Appeal of the Planning Manager Decision approving permits for:

to allow the proposed road improvements to Willamette Falls Drive, including the roundabout, to be developed on riparian land in Fields Bridge Park and right of way.

AP-23-02

Karie Oakes and Teri Cummings

West Linn, Oregon | Figure 1

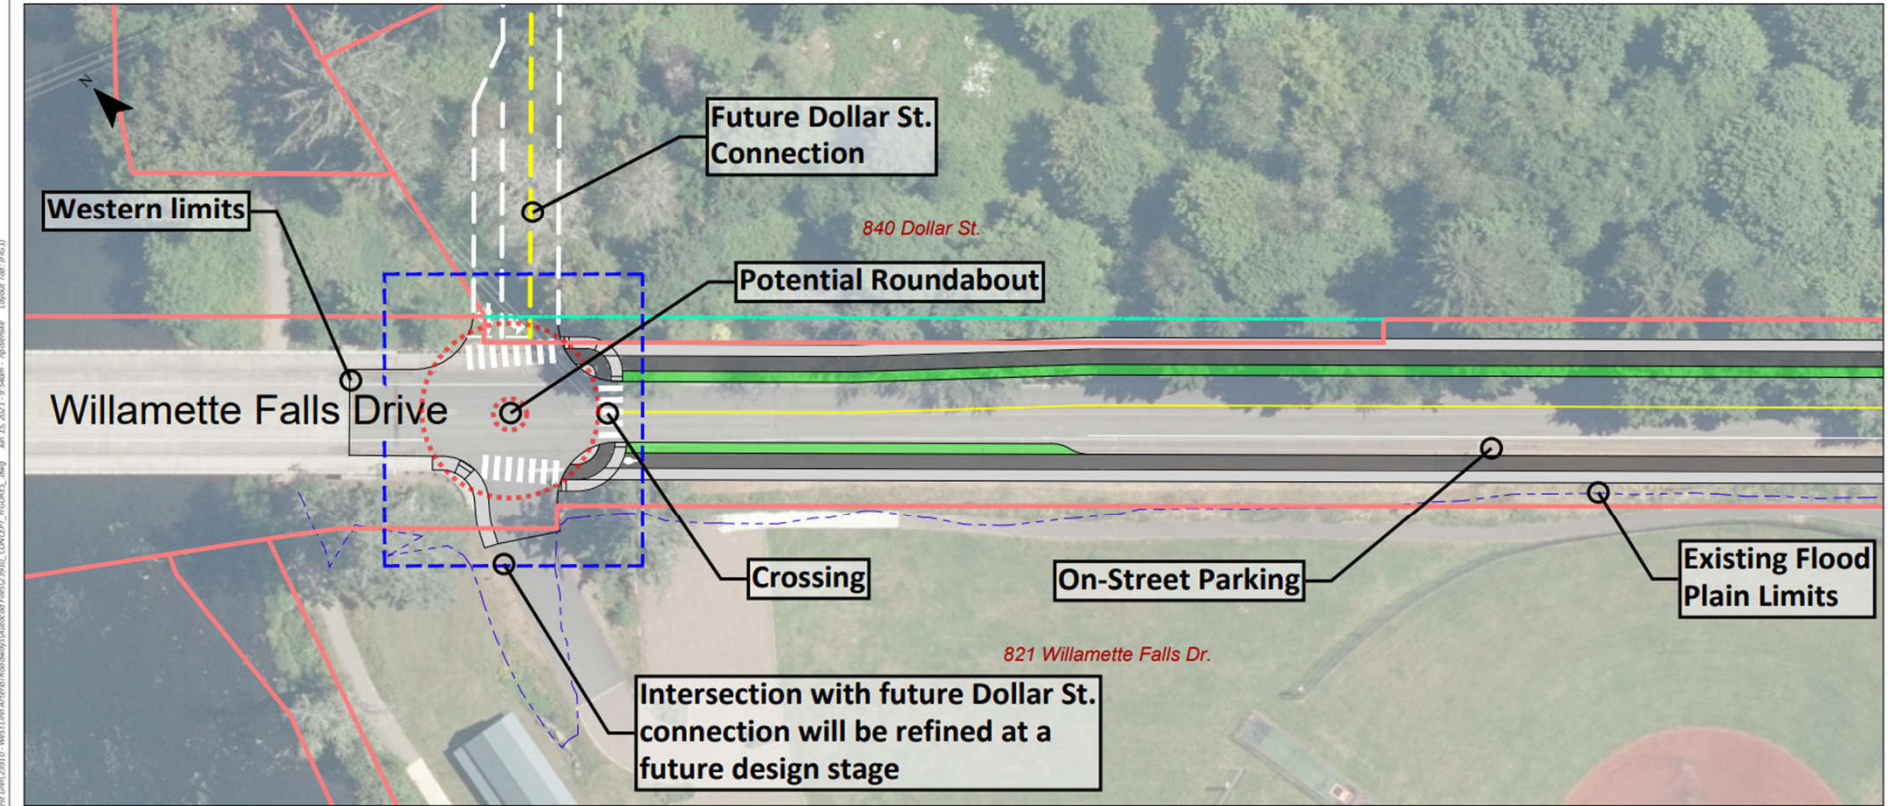
The roundabout next to Fields Bridge was identified as a “potential roundabout” in the WFD Concept Plan.

It was yet-to-be-determined whether the intersection near Fields Bridge would be better as a roundabout or a conventional crosswise intersection.

FIGURE
6F

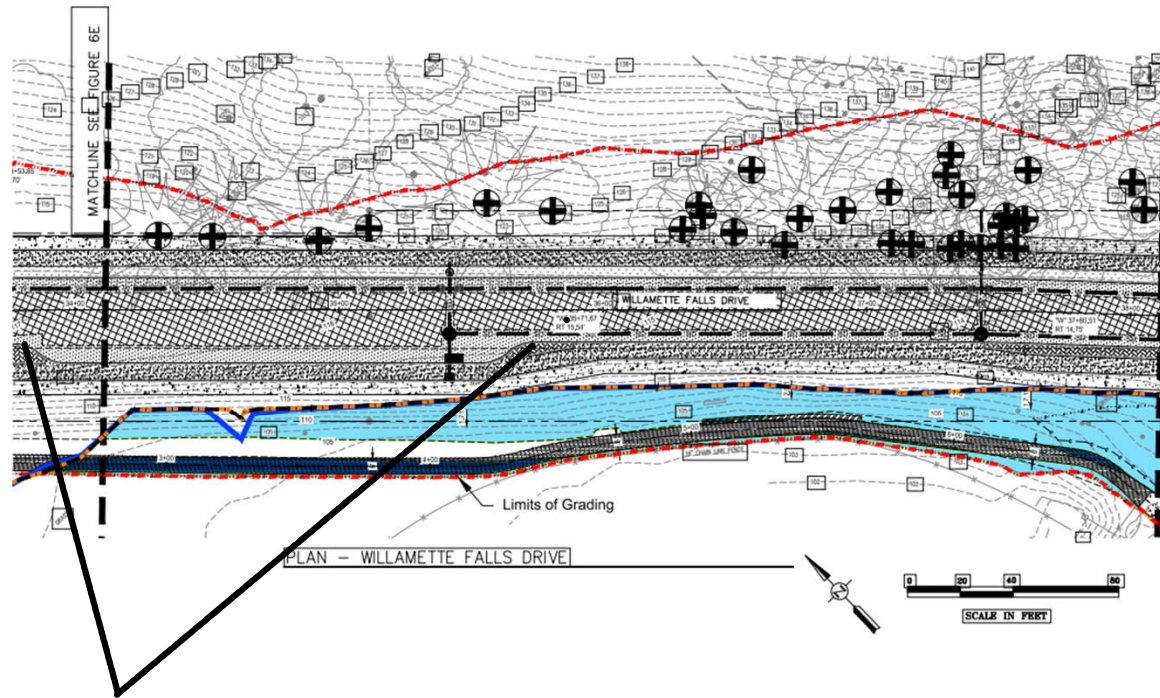
No, two proposed on-street parallel parking areas would cause WFD improvements to encroach further into the Habitat Conservation Area (HCA) and flood plain as shown in Figures 6F, 6H and 6I.

On-street parking is not an essential, unavoidable component of the project and is inconsistent with the purpose of the project to increase safety for all modes of transportation and to install ped/bike paths and a roundabout.

The widened area for the proposed parking pushes the ped/bike path into the habitat conservation area (HCA).

Remove the on-street parking to meet the purpose of the project and the following approval criteria:

28.110 A.2. HCAs (Habitat Conservation Areas) shall be avoided to the greatest extent possible and development activities shall be instead directed to the areas not designated "Habitat Impact Areas not designated as HCAs, consistent with subsection (A) (3) of this section.

28.110 L. Roads, driveways, utilities, or passive use recreation facilities. Roads, driveways, utilities, public paths, or passive use recreation facilities may be built in those portions of HCAs that include wetlands, riparian areas, and water resource areas when no other practical alternative exists but shall use water-permeable materials unless City engineering standards do not allow that. Construction to the minimum dimensional standards for roads is required. Full mitigation and revegetation are required, with the applicant to submit a mitigation plan pursuant to CDC 32.070 and a revegetation plan pursuant to CDC 32.080.

Site Plan **FIGURE 6H**
 Willamette Falls Drive Public Improvements - West Linn, Oregon

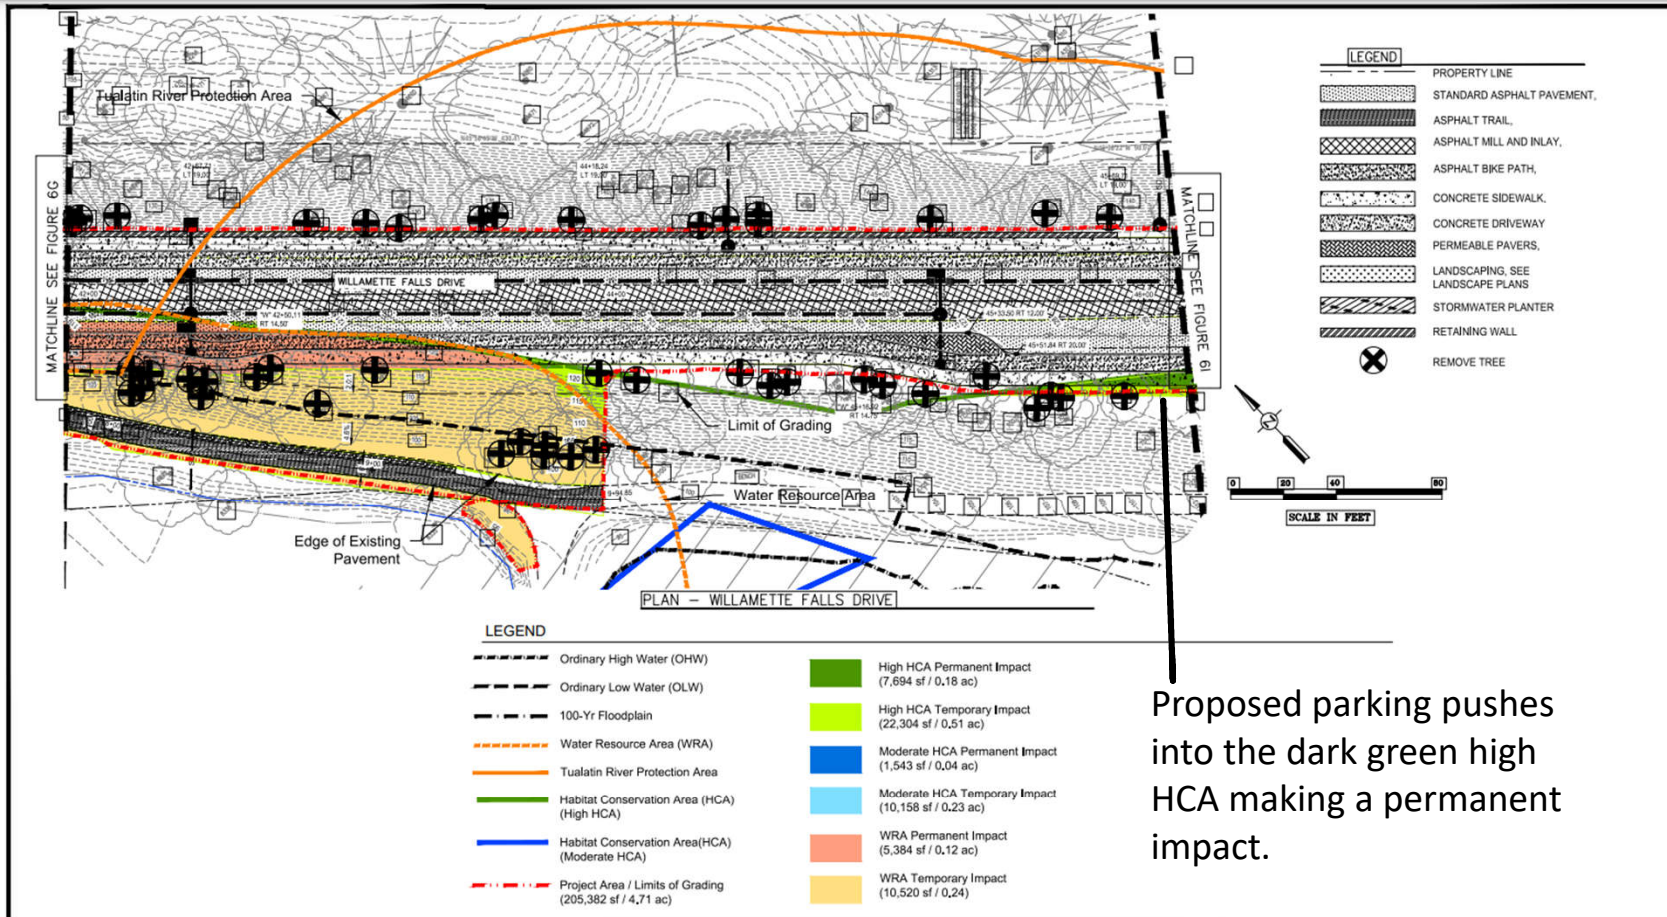
Proposed parking pushes into the dark green high HCA making a permanent impact.

FIGURE
61

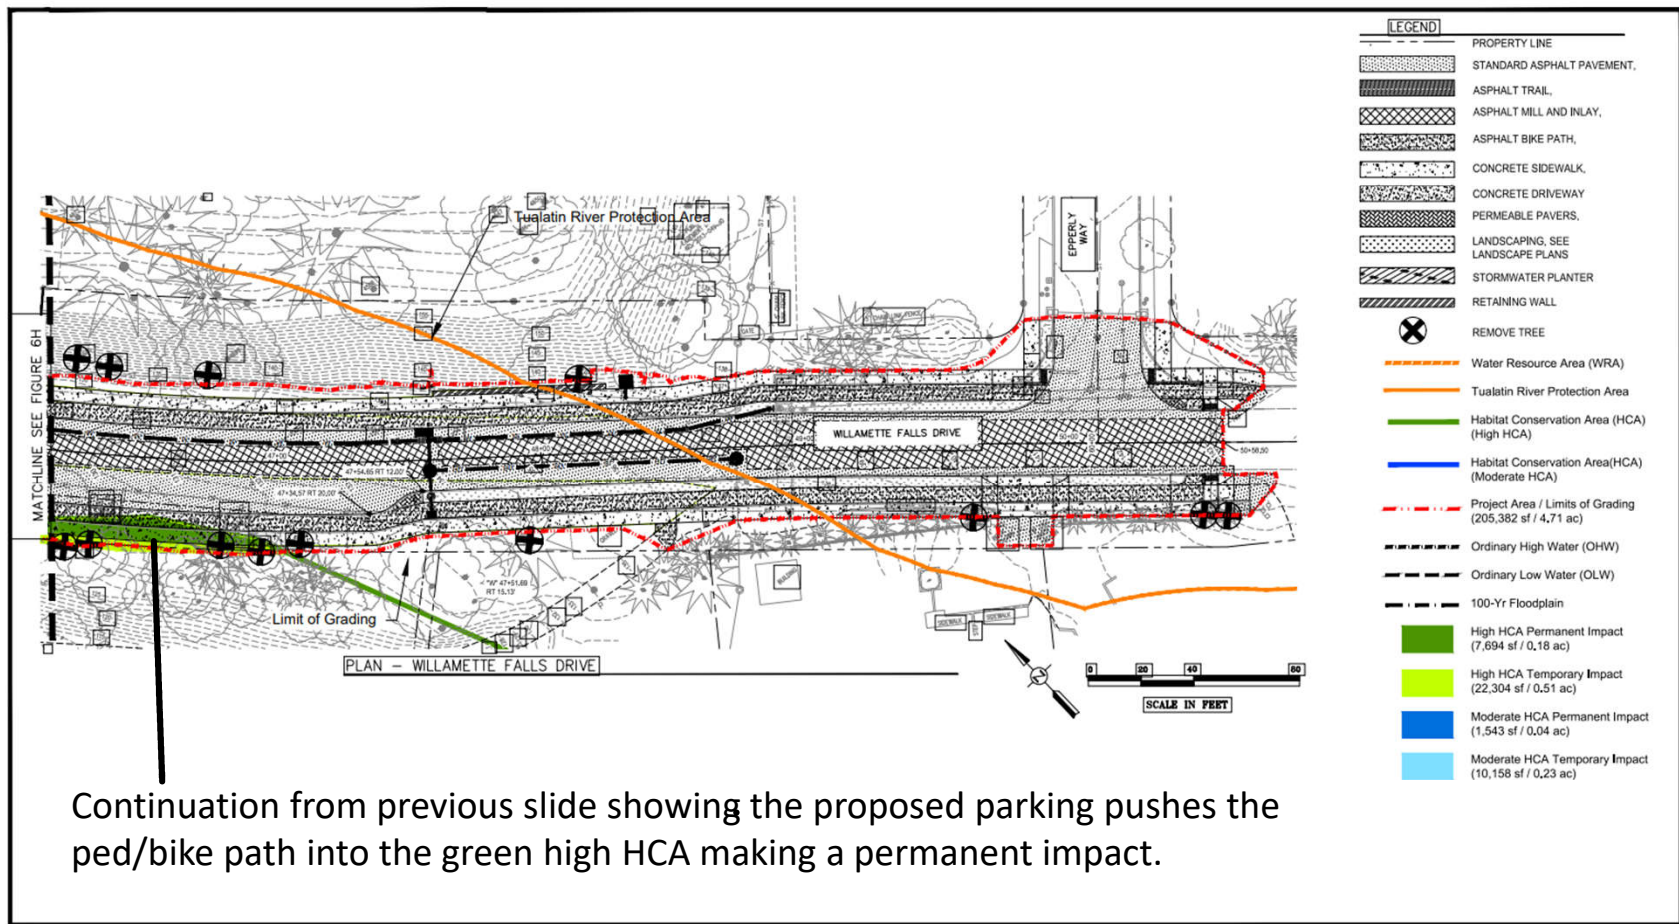
Continuation from previous slide showing the proposed parking pushes the ped/bike path into the green high HCA making a permanent impact.

Guardrail to Driveway

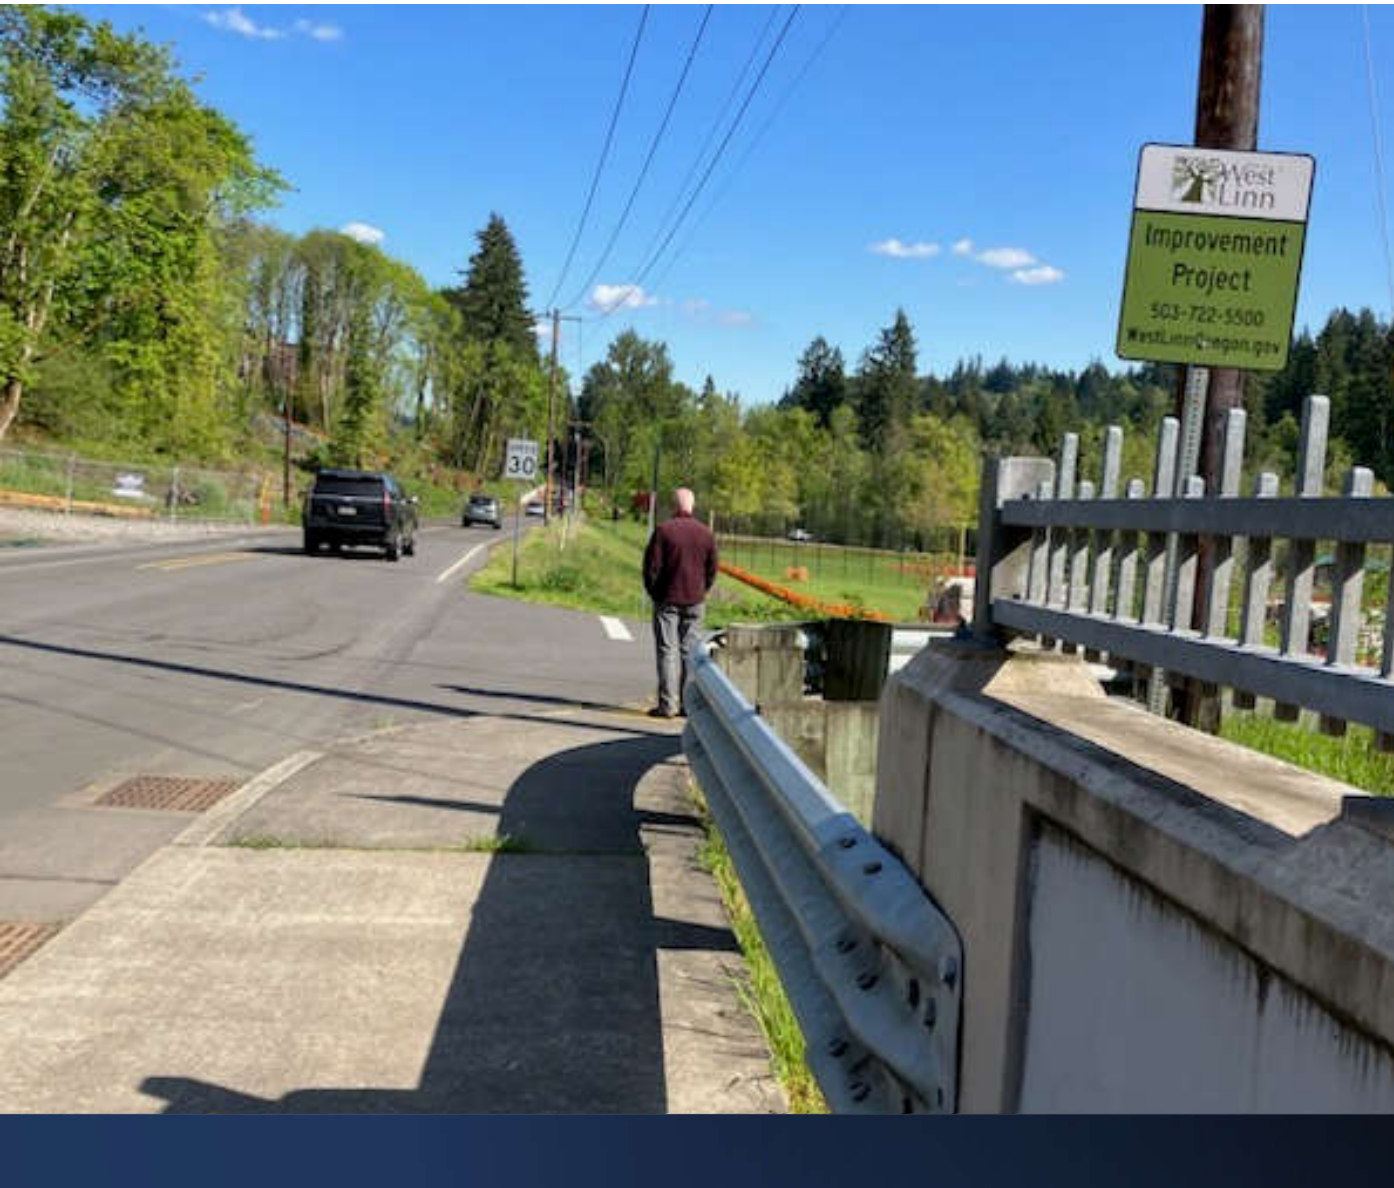
The solid concrete and iron guardrail on Fields Bridge appear to obstruct the clear vision area of the intersection as required by CDC 42.020.

The steep downward slope of the driveway into Fields Bridge Park could also impair line of sight approaching the intersection.

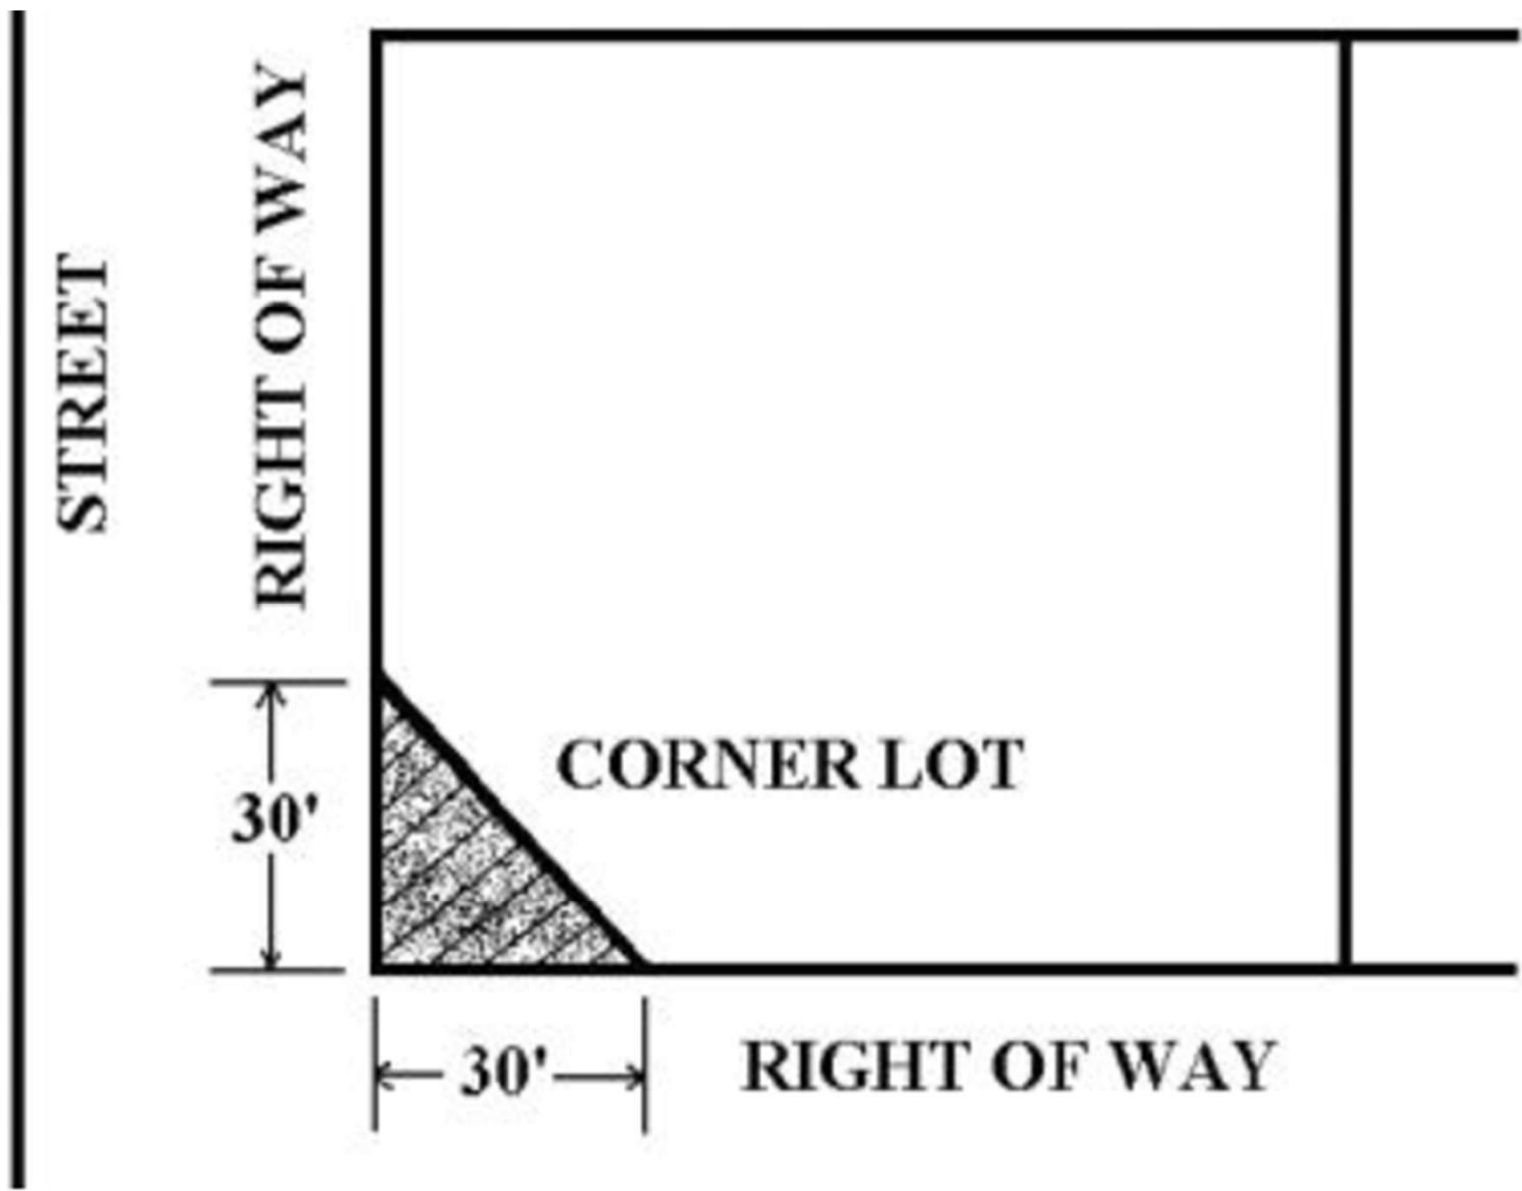
- Distance to corner is 27 ft, requirement is 30 ft.
- Height is over 5 ft, requirement is under 3 ft.

SHEET NUMBER
L1001 PAGE
A

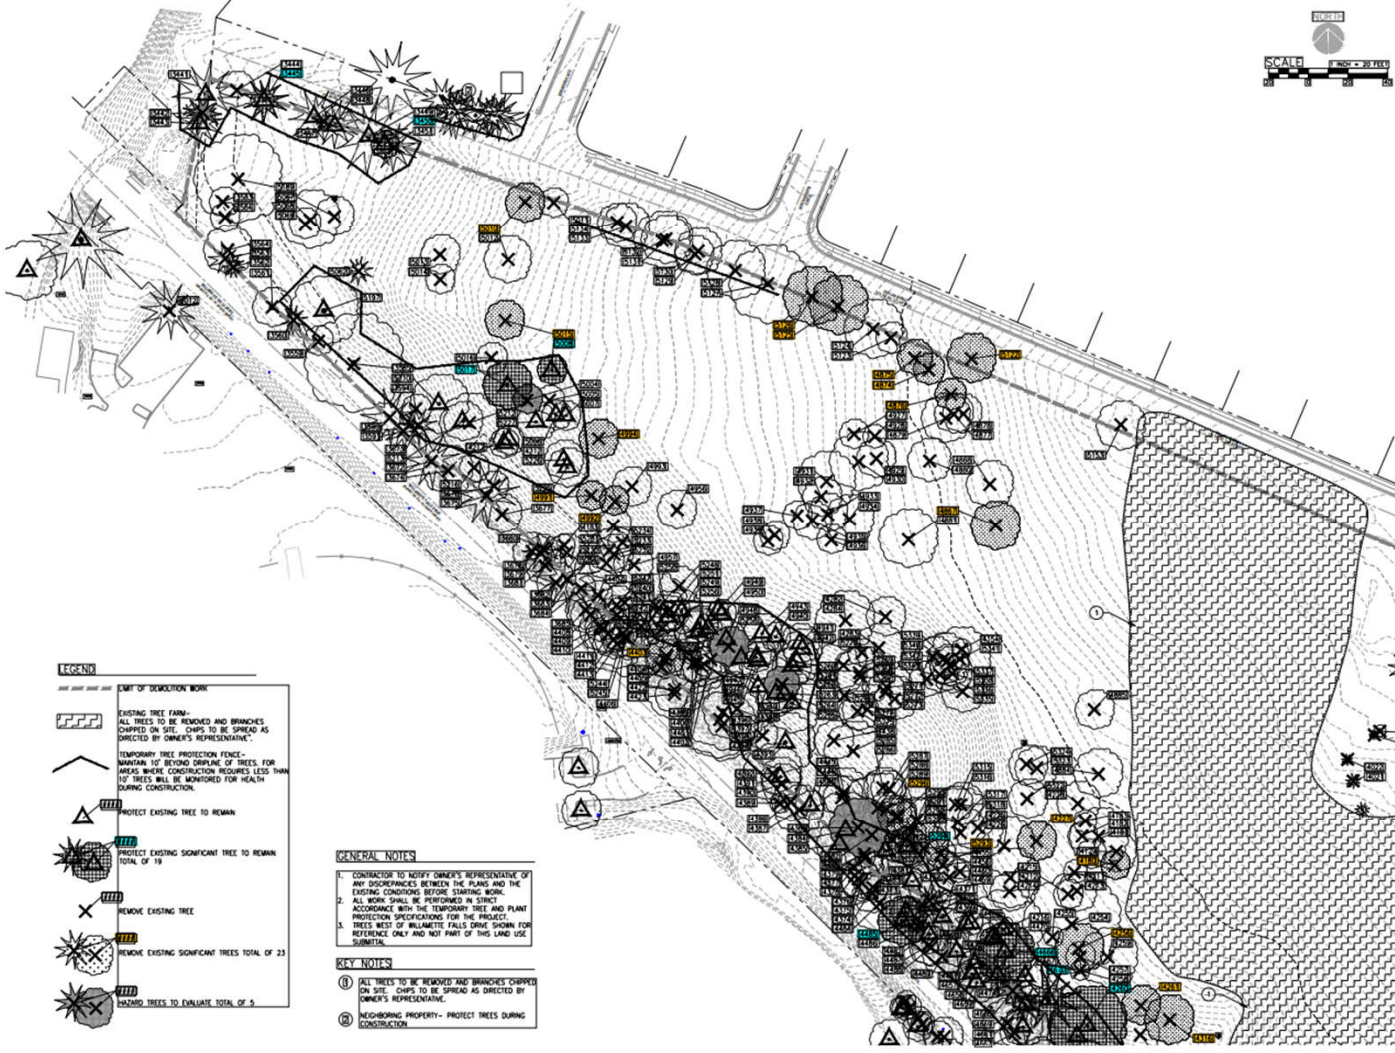
A disclaimer in the General note on the New Athey Creek Middle School Tree Protection Plan project sheets L1001 and L1002, dated May 17, 2021, states in General Note 3: **TREES WEST OF WILLAMETTE FALLS DRIVE SHOWN FOR REFERENCE ONLY AND NOT PART OF THIS LAND USE SUBMITTAL.**

Thus, there was no removal/protection plan in place before the City allowed at least 41 trees to be cut down in Fields Bridge Park.
